Journal Name:	<u>British Journal of Applied Science & Technology</u>
Manuscript Number:	MS: 2013_BJAST_4430
Title of the Manuscript:	High performance thermal properties of natural pumice-based bricks
Type of the Article	Research paper

PART 2: Review Comments

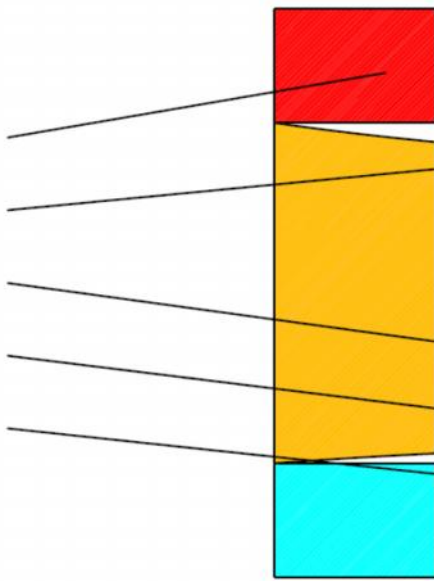
PLATO CALIENTE CAPA DE AIRE PIEZA CERAMICA CAPA DE AIRE PLATO FRIO 	
	No se sabe con claridad cuántas muestras se han utilizado ni se da ningún análisis estadístico. <i>It is not clear how many samples have been used and any statistical analysis is done.</i>	In the corrections is mentioned the number, characteristics and qualities of the analysed samples. Also the information about test conditions is shown in Table 5 as a result of the thermal conductivity test.
	Se recomienda ver el siguiente artículo lo referente al análisis térmico: <i>It is recommended to see the following paper regarding thermal analysis:</i> “Improving the thermal transmittance of single-brick walls built of clay bricks lightened with paper pulp”, P. Muñoz, M.C. Juárez, M.P. Morales, M.A. Mendivil Energy and Buildings, Volume 59, April 2013, Pages 171–180. http://dx.doi.org/10.1016/j.enbuild.2012.12.022	We have seen the article and we included a reference
